## - Service Installation Notice -

Kit No.: 9010418 - CIRCUIT BREAKER (FUSE) KIT, SWPR, W/ RELAY

Models: S9 and Scout 9 Sweepers

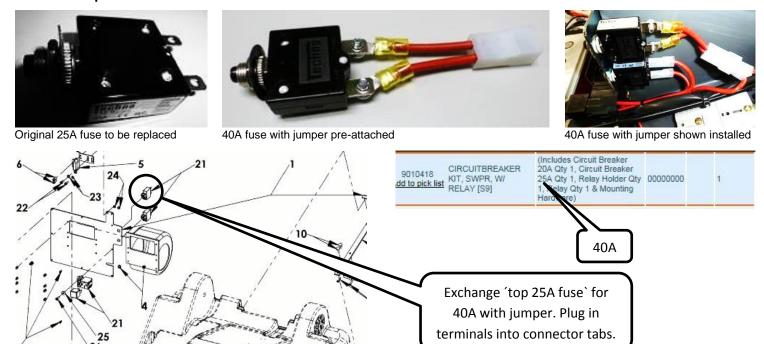
For this kit, the original 25amp circuit breaker/fuse for the brush drive circuit has been replaced by a 40amp circuit breaker/fuse with jumper connector. No wire harness change has taken place.
